Technical Specification Group Services and System Aspects **TSGS#18(02)0775**

Source: TSG SA WG2
Title: CRs on 23.221
Agenda Item: 7.2.3

CR-Form-v7	
CHANGE REQUEST	
№ 23.221 CR 37	№ rev 1 № Current version: 5.6.0 №

CR-Form-v7
CHANGE REQUEST
⌘ 23.221 CR 38 ⌘ rev 1 ⌘ Current version: 5.6.0 ⌘

Figure 5-5 UE Accessing IM Subsystem Services with GGSN in the visited network

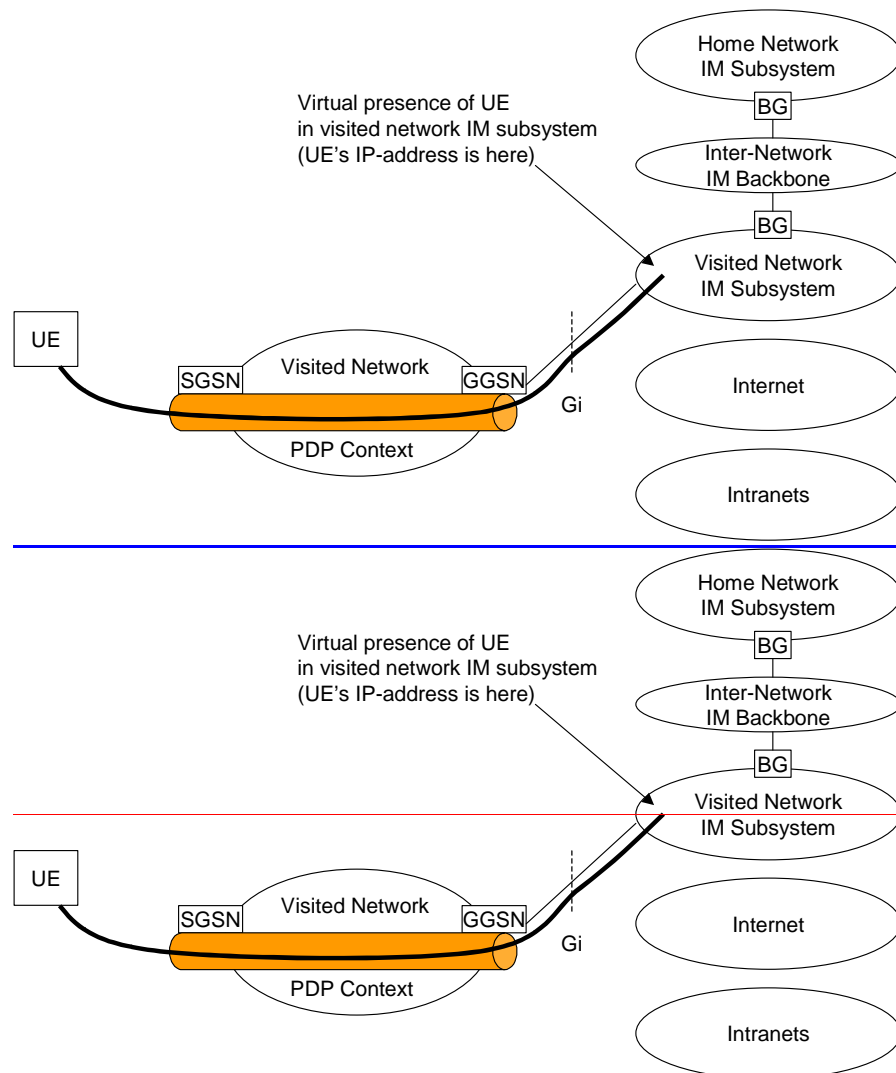
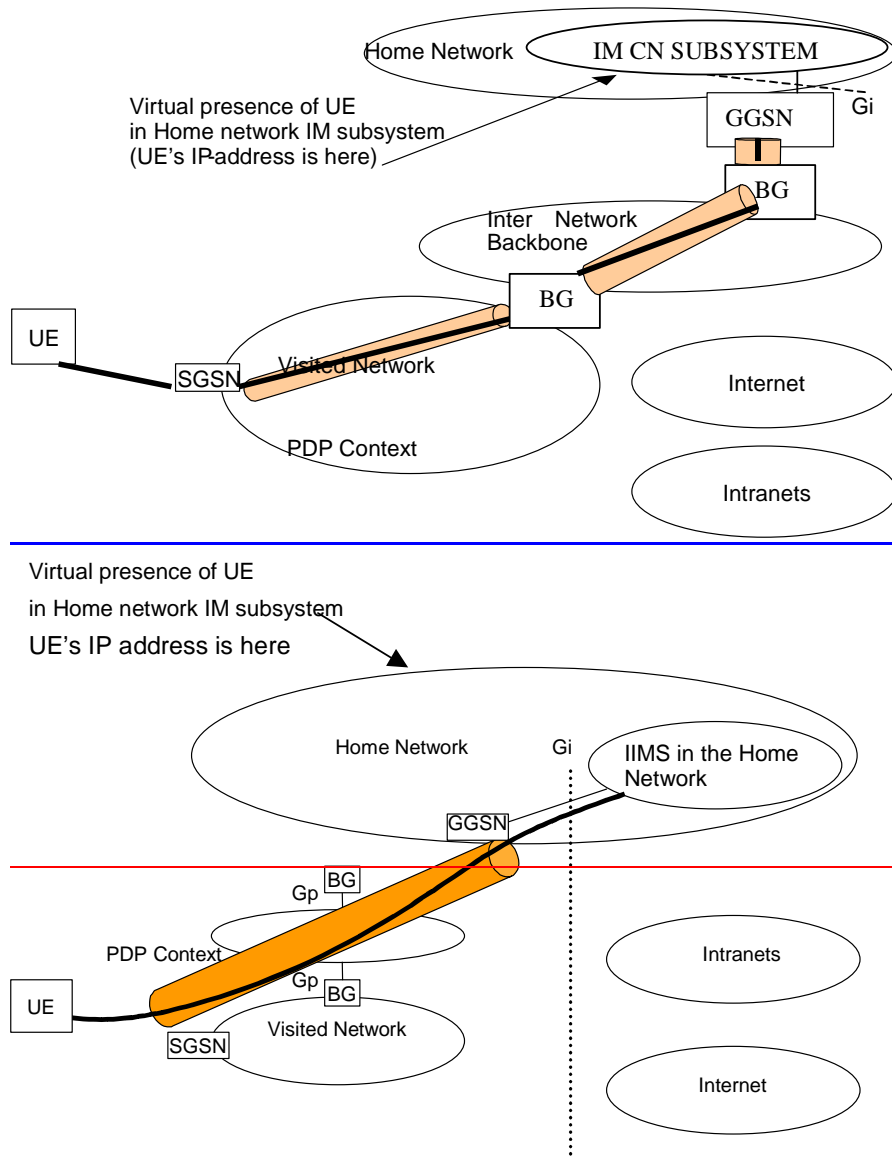
Reason for change:	№ Text and figures related to address management were duplicated in 23.228 and 23.221 with slight differences. The duplicate text was agreed to be removed from 23.228. This CR replaces the text in 23.221 with text that is consistent with that removed from 23.228.
Summary of change:	№ Replace the text of Clause 5.4.
Consequences if not approved:	№ Text and figures may get out of sync leading to conflicting information and implementation errors.

~~This section deals with a UE making access to IM-subsystem services only and via UMTS.~~

~~A UE accessing IM-Subsystem services requires an IP address which is logically part of the Serving Network IM Subsystem IP Addressing Domain. This is established using an appropriate PDP-context. It is possible to connect to a GGSN either in the VPLMN or the HPLMN. For routing efficiency this context may benefit from being connected through an GGSN in the visited network. Examples of the connection between the UE and the Visited Network IM Subsystem is shown below in figure 5-5 (GGSN in VPLMN) and 5-5a (GGSN in HPLMN):~~

This section deals with a UE accessing IM CN subsystem services via UMTS.

A UE accessing IM CN Subsystem services requires an IP address that is logically part of the IM CN subsystem IP Addressing Domain. This is established using an appropriate PDP-context. It is possible to connect to a GGSN either in the VPLMN or the HPLMN. For routing efficiency this context may benefit from being connected through a GGSN in the visited network. The connection between the UE and the IM CN subsystem (where the GGSN is either in the Home or the Visited network) is shown below:
